Product Change Notification / SYST-16EQYH046

ERRATA - ATxmega128/64B3 Silicon Errata and Data Sheet Clarification Document Revision

ATxmega128/64B3

Silicon Errata and Data Sheet Clarification

Figure 3-1. ADC Overview

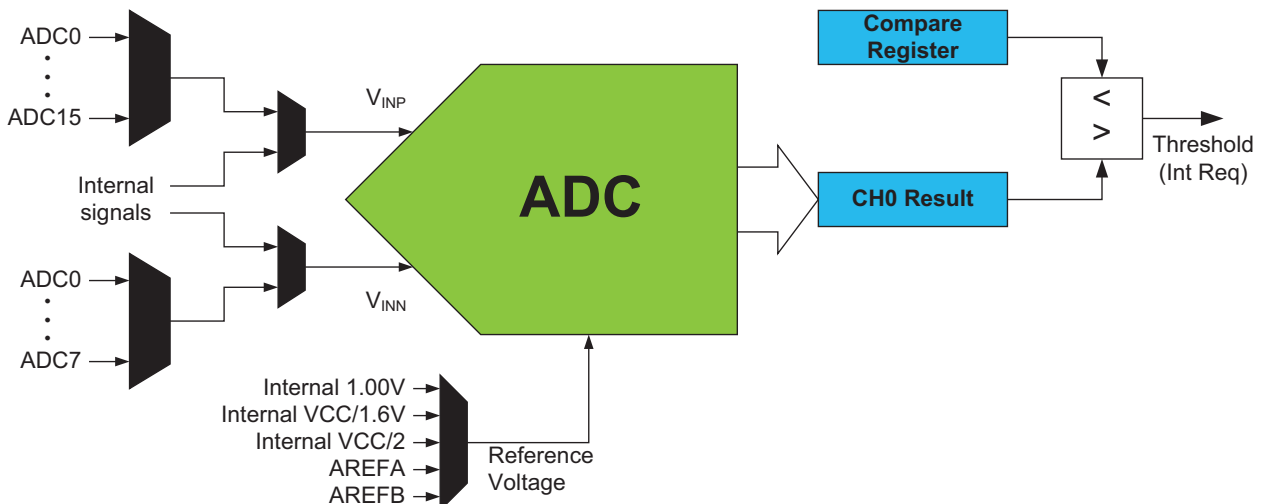
- 1) Content moved from the data sheet and restructured to the new document template
- 2) Added data sheet clarification section 3.2. ADC – 12-bit Analog to Digital Converter and added a note in 3.2.1. Overview

3.2 ADC – 12-bit Analog to Digital Converter

3.2.1 Overview

Note: After the ADC is enabled, the first sample may deviate from the expected result. It is recommended to discard the first sample or accumulate several samples.
